Model: 500 sheet Finisher(SR3050)	Date: 26-Dec-07	No.: RD372001a
--	-----------------	----------------

Subject: Firmware Release Note: 500 sheet Finisher(SR3050)		Prepared by: S.Tomoe	
From: 2nd Tech. Support Sec. Service Support Dept.			
Classification:	<input type="checkbox"/> Troubleshooting	<input type="checkbox"/> Part information	<input type="checkbox"/> Action required
	<input type="checkbox"/> Mechanical	<input type="checkbox"/> Electrical	<input type="checkbox"/> Service manual revision
	<input type="checkbox"/> Paper path	<input type="checkbox"/> Transmit/receive	<input type="checkbox"/> Retrofit information
	<input checked="" type="checkbox"/> Other ()

Model: R-C5 500 sheet Finisher (SR3050)		Date: 08-Apr-10	No.: RD372002
Subject: PCB short		Prepared by: T. Nihei	
From: 1st Overseas Tech Support Sec., 1st PQM Dept.			
Classification:	<input type="checkbox"/> Troubleshooting	<input checked="" type="checkbox"/> Part information	<input type="checkbox"/> Action required
	<input type="checkbox"/> Mechanical	<input type="checkbox"/> Electrical	<input type="checkbox"/> Service manual revision
	<input type="checkbox"/> Paper path	<input type="checkbox"/> Transmit/receive	<inpu

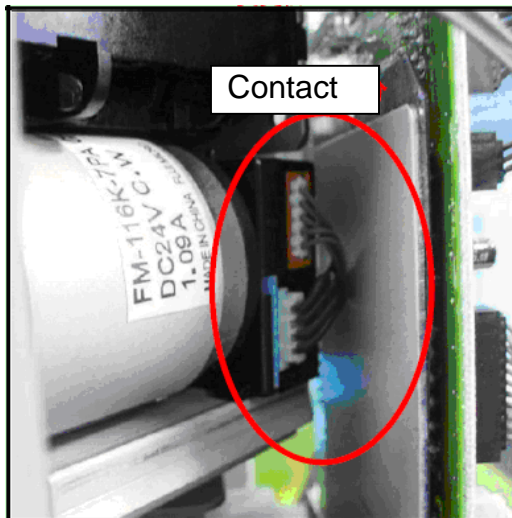
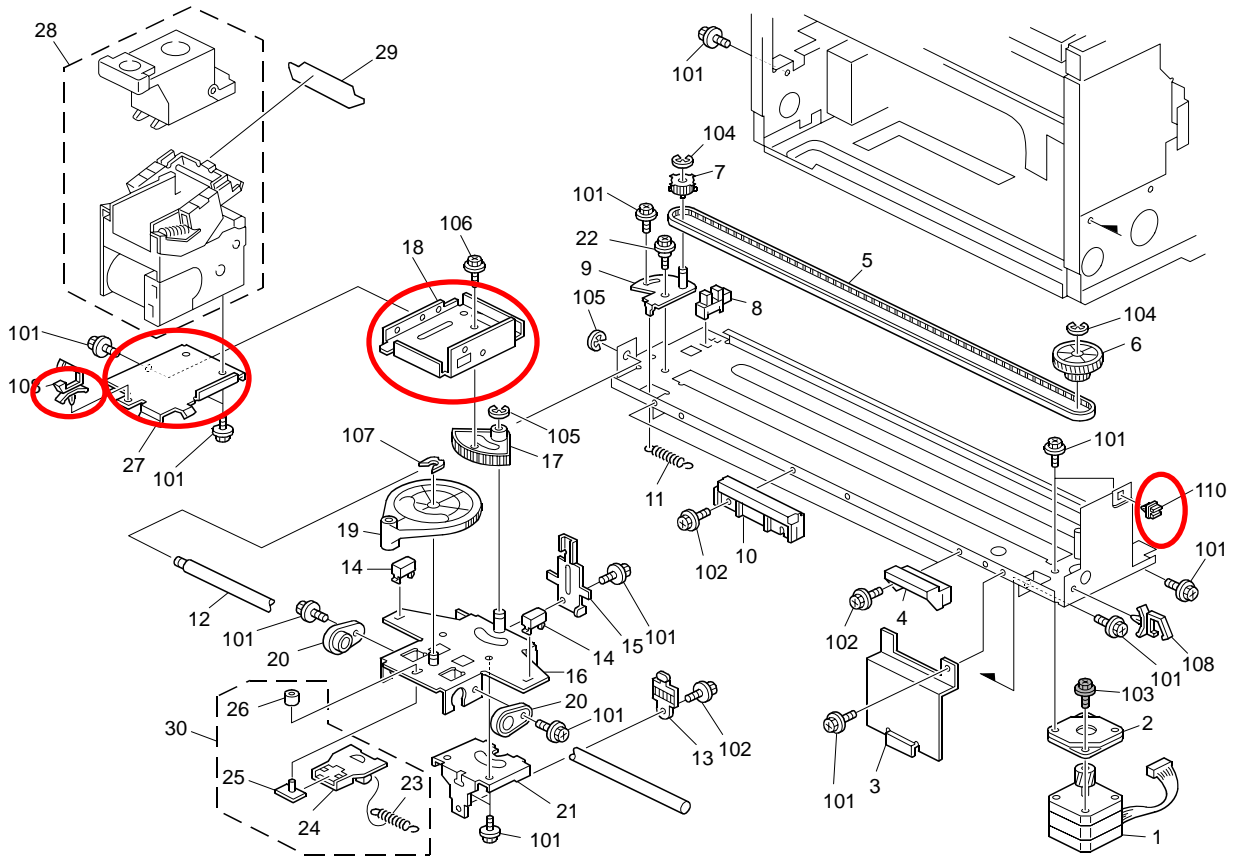
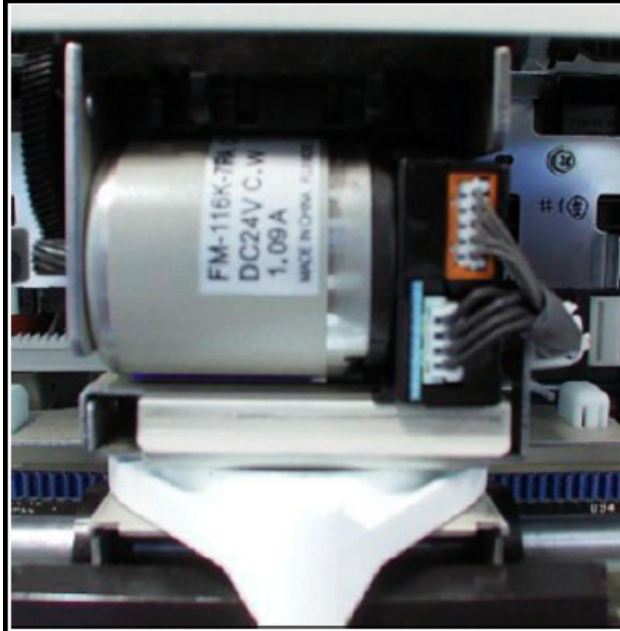
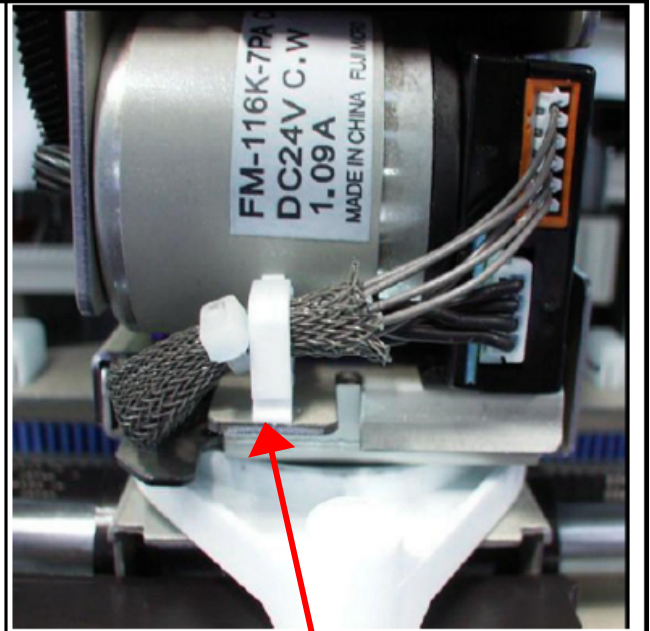
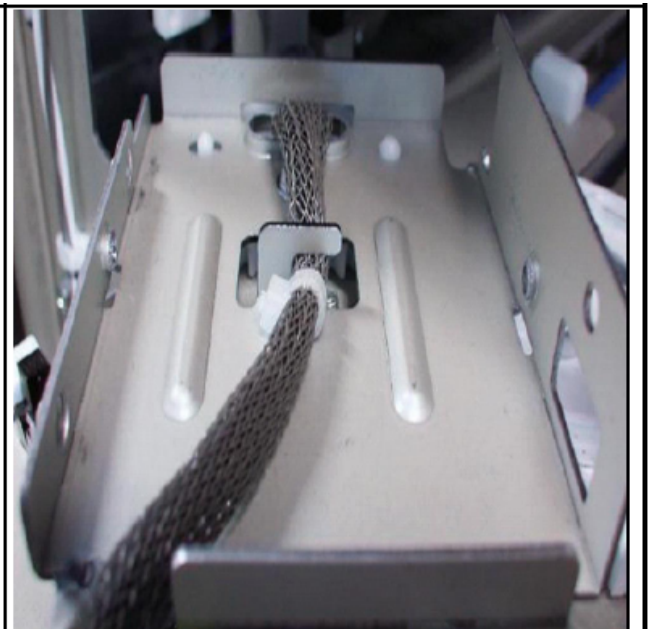
Change:

- 1) An opening was made in the stay.
- 2) A locking support was added.
- 3) The routing of the harness was changed.

Reason: To ensure that the harness does not contact the stay (which can put pressure on the pins of the PCB behind the stay).

Important: When you install the new parts, make sure to reroute the harness as shown on the last page of this RTB.

If you install the new parts, reroute the harness as shown in the photos marked "New".

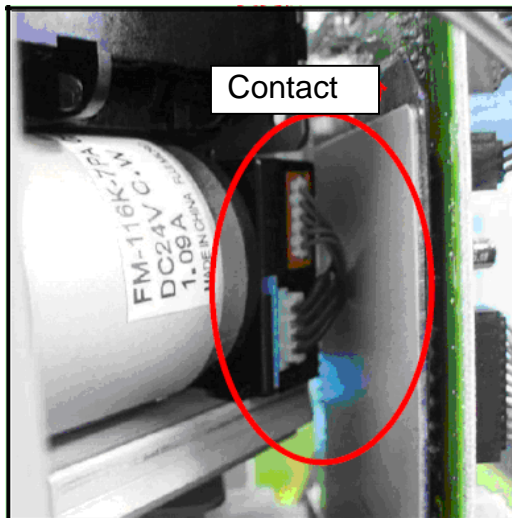
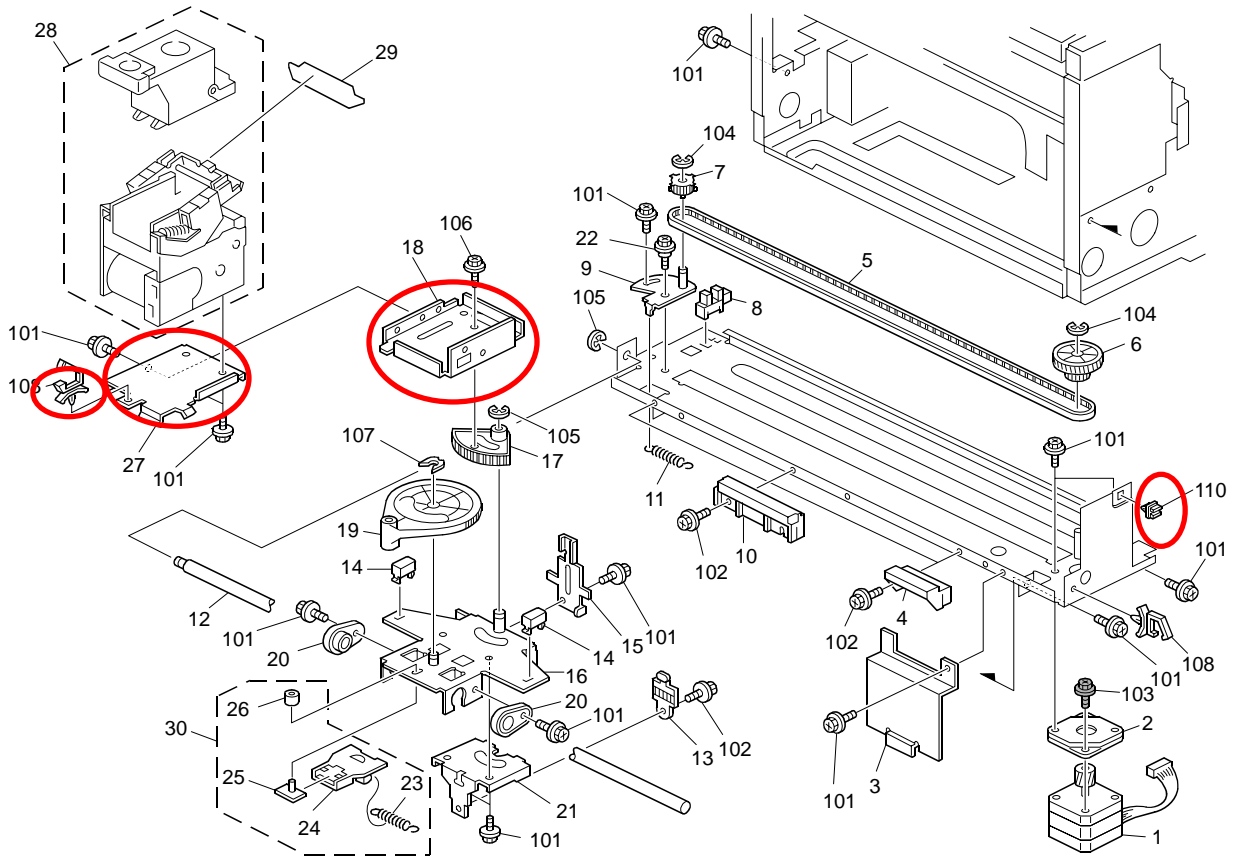
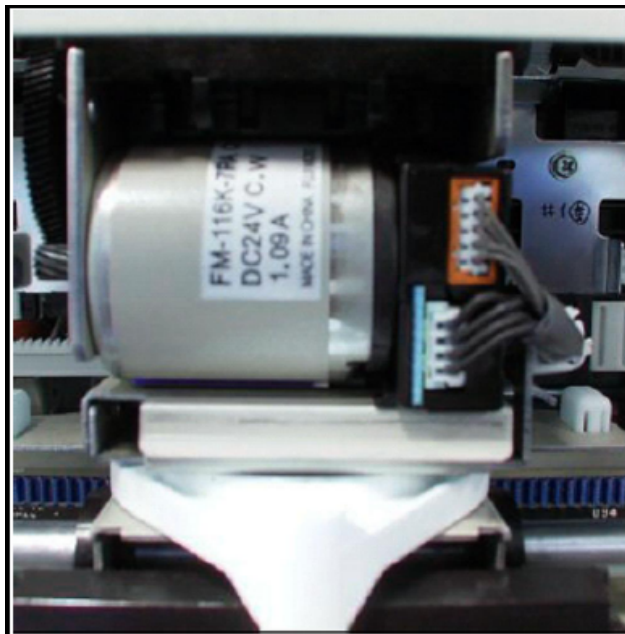
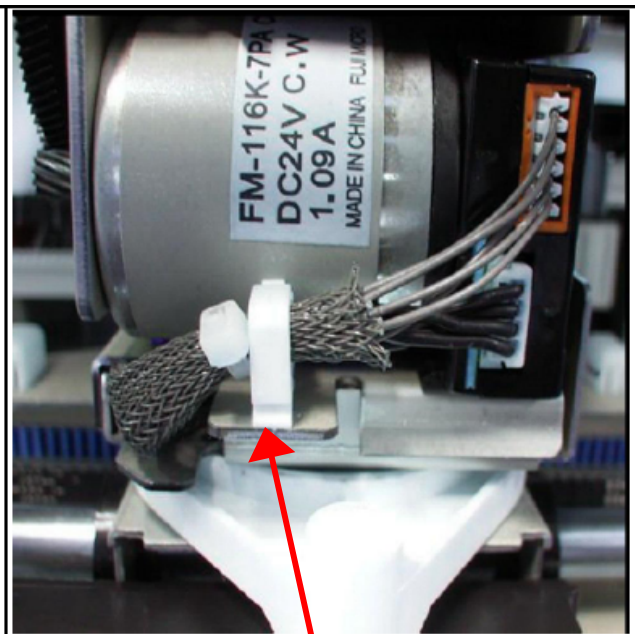
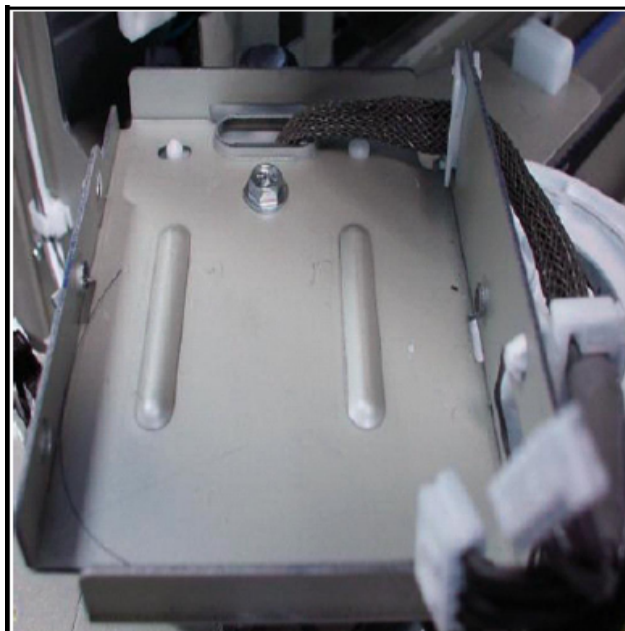
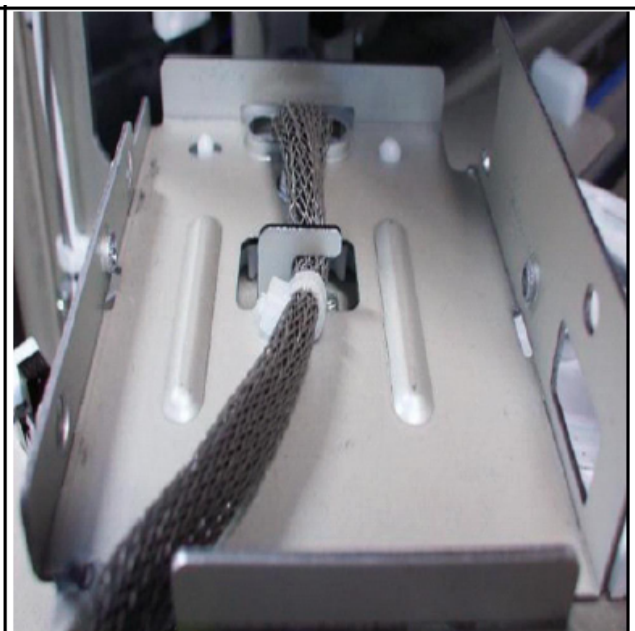
Change:

- 1) An opening was made in the stay.
- 2) A locking support was added.
- 3) The routing of the harness was changed.

Reason: To ensure that the harness does not contact the stay (which can put pressure on the pins of the PCB behind the stay).

Important: When you install the new parts, make sure to reroute the harness as shown on the last page of this RTB.

If you install the new parts, reroute the harness as shown in the photos marked "New".

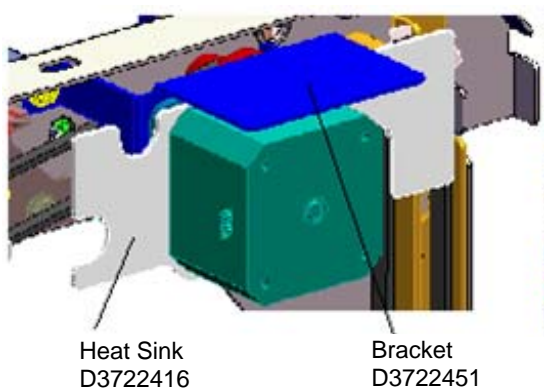
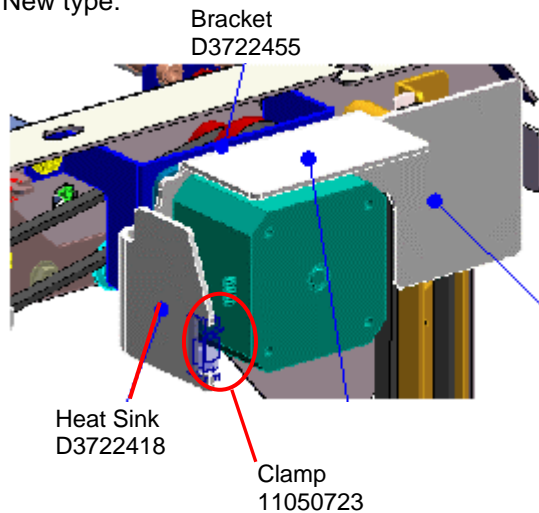
Changes:

- 1) The shapes of the bracket and the heat sink were changed.
- 2) A clamp was added to the heat sink.

Reason: To further increase the resistance to high temperatures.

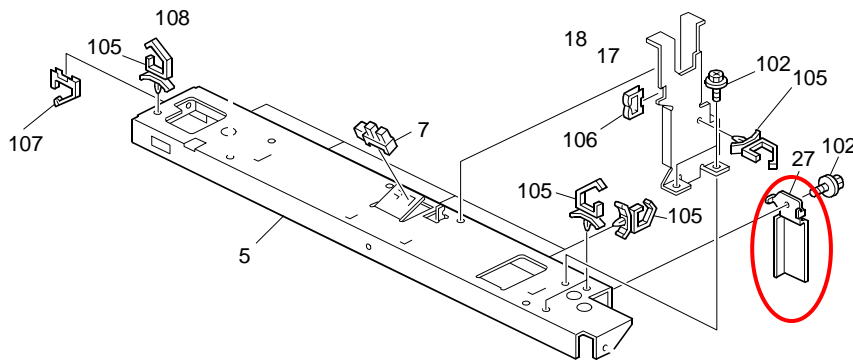
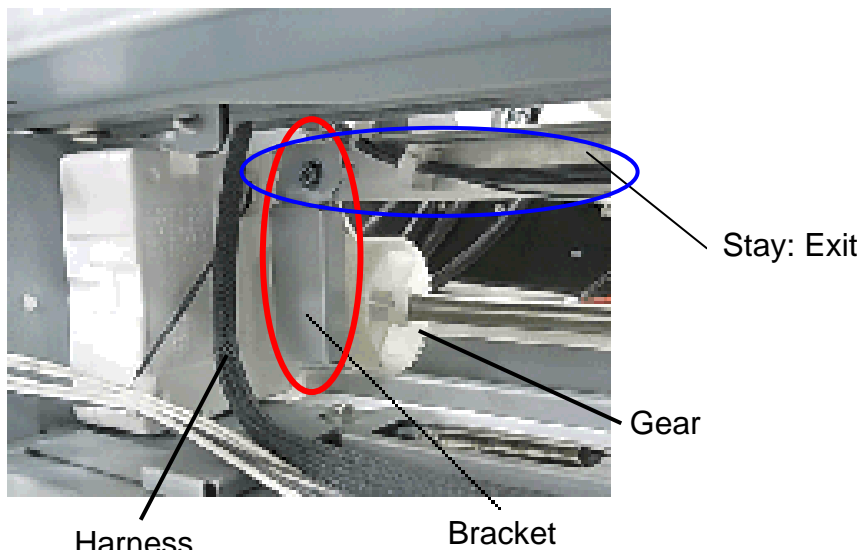
Change:

- 1) A bracket and tapping screw for the harness guide were added.
- 2) The shape of the exit stay was changed (a screw hole was added).

Reason: To further ensure that the harness does not come into contact with the gear.

The affected stapler unit is shown in the illustration below (Index #24):

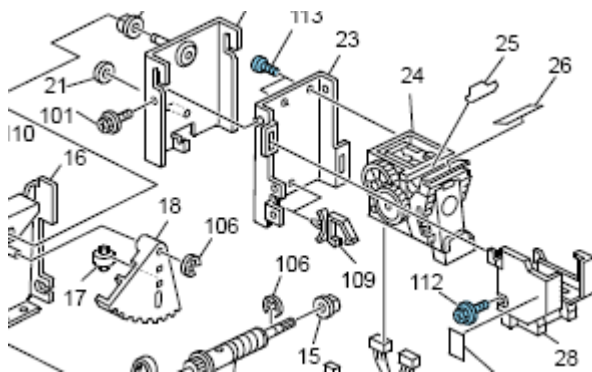
Some parts of the stapler unit (black resin parts shown below) contained PBDE material in excess of the limits set by the RoHS Directive.

The vendor of these parts used irregular materials during the manufacturing process. Production period: June to September 2010 (refer to the S/N table below)

Replace the stapler unit.
